CITY OF WASHINGTON, ILLINOIS

Public Works Committee Agenda Communication

Agenda Item: Trails Edge Section 9 and 10 Alternate Typical Section

Re: Trails Edge Sec. 9 Alternate Typ. Section Request

ROADWAY TYPICAL SECTION RESIDENTIAL STREET (MINOR)

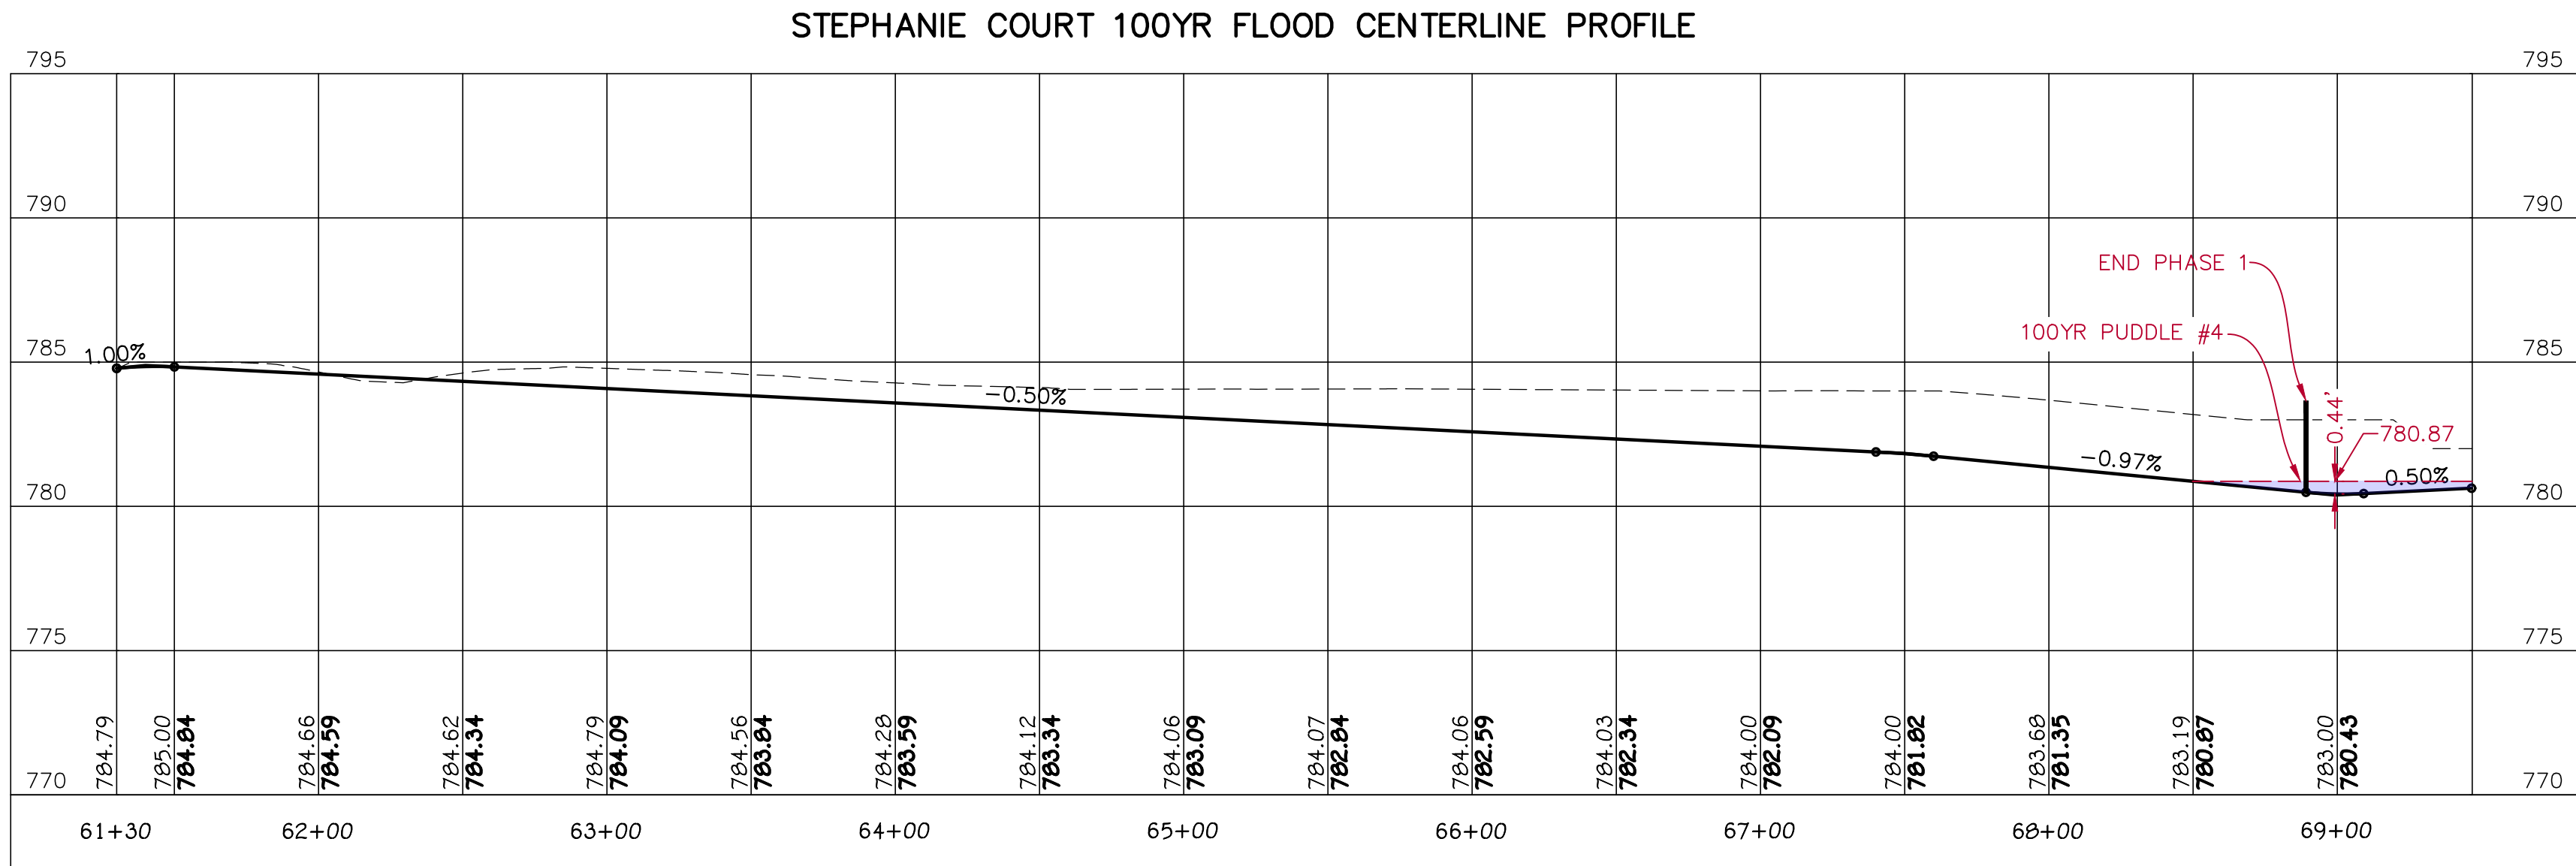
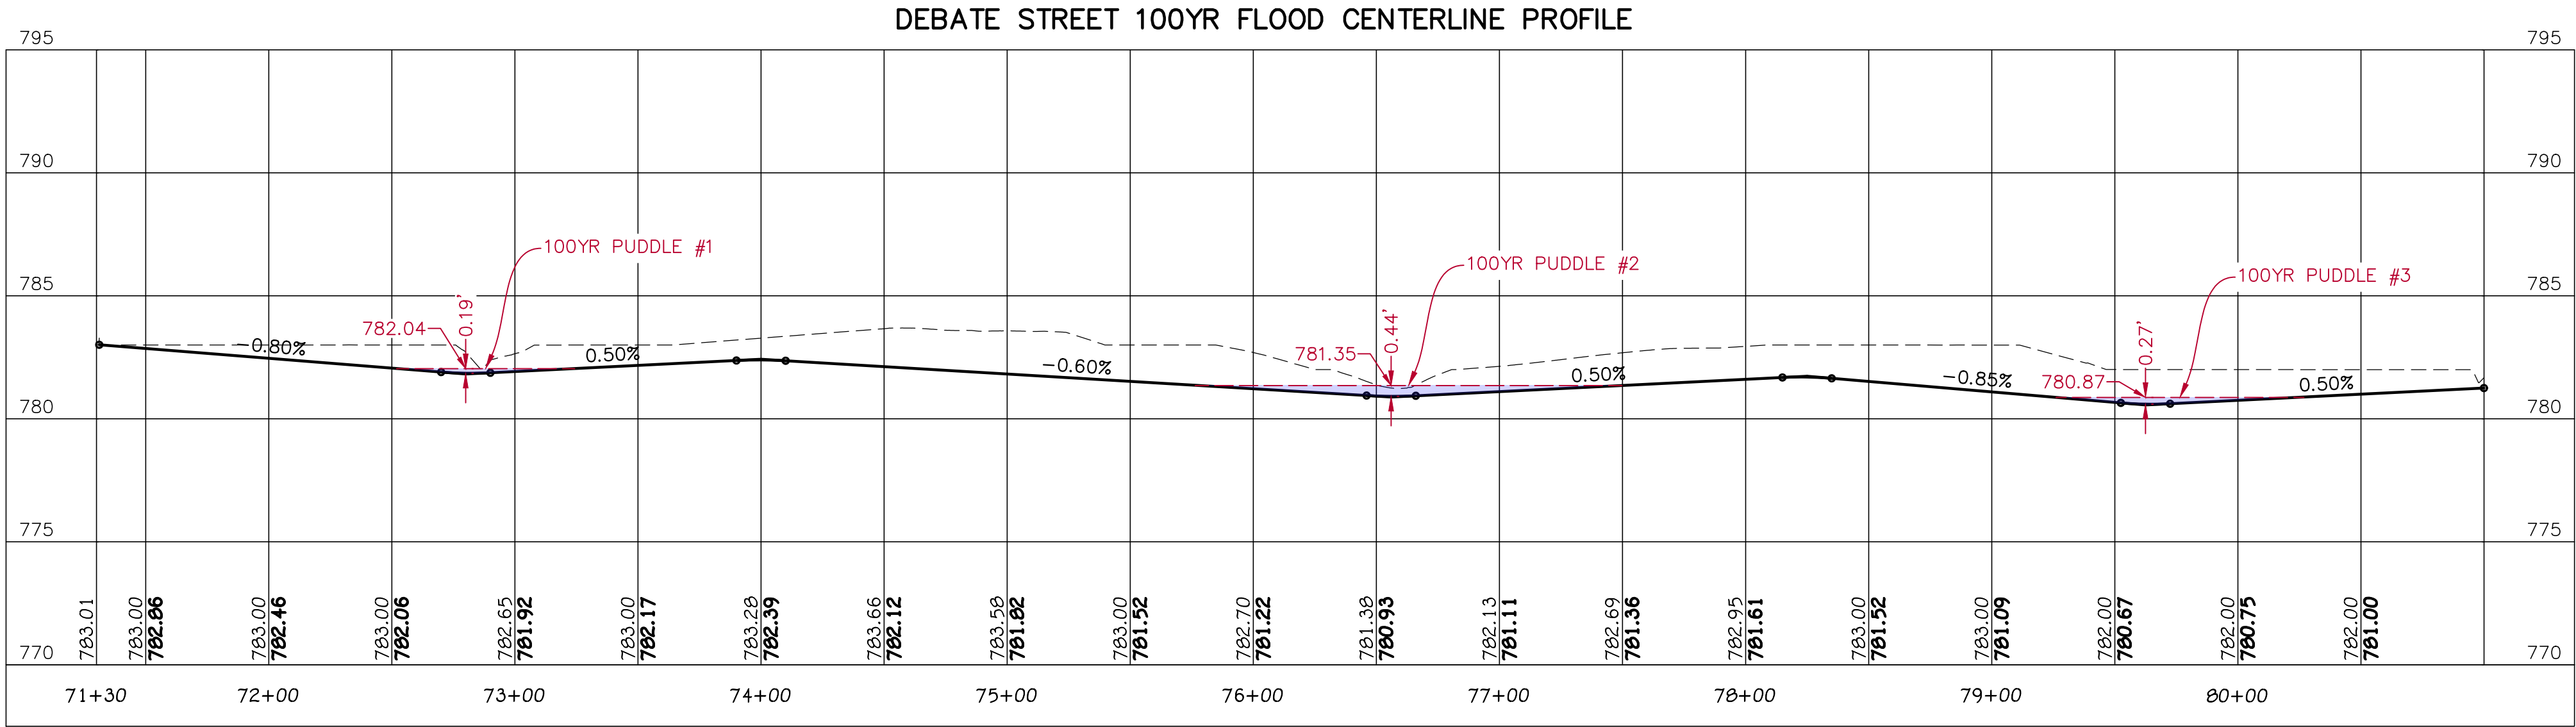
Explanation: Potential developers for the Trails Edge Section 9&10 property have recently been in contact with City Staff about drainage concerns. With the topography of this property, the existing drainage, and the increase in rainfall intensity design guidelines, the 100-year flood route was exceeding the curb line in a few low areas of the proposed roadway. The City's Stormwater ordinance allows for the 100-year flood route to be in the roadway, but it cannot exceed the height of the curb. To keep the water inside the curb, the cross slope of the roadway was reduced from 2% to 1% and the curb height was increased from 6" to 8".

The proposed profile of Debate Street and the proposed intersection of Debate Street and Stephanie Court were designed to minimize the depth of water at the curb. This being the case, the standard typical City of Washington Typical Section would have water at a depth of 10" at the curb and by reducing the cross-slope from 2% to 1% and by increasing the curb height from 6" to 8" we can convey the 100YR flood water without exceeding the top of curb.
